AMENDMENTS TO THE DRAWINGS

REMARKS

S/N: 10/642,670

FIG. 9
(PRIOR ART)

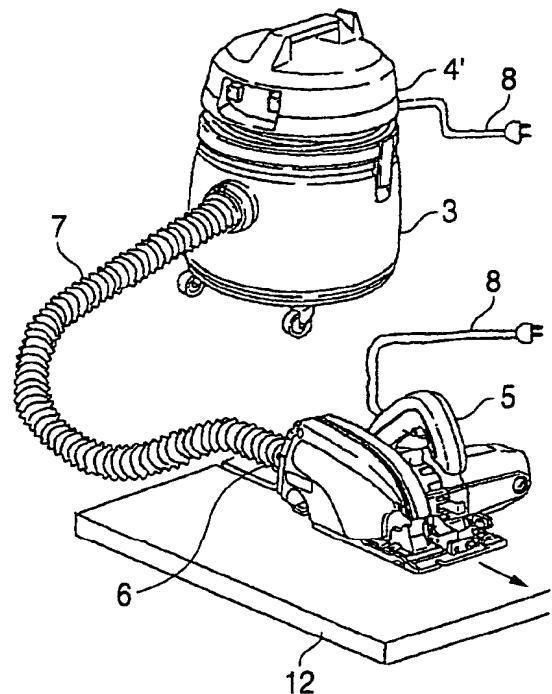
Figs. 9 and 10 have been amended to include the text, “(PRIOR ART)”.
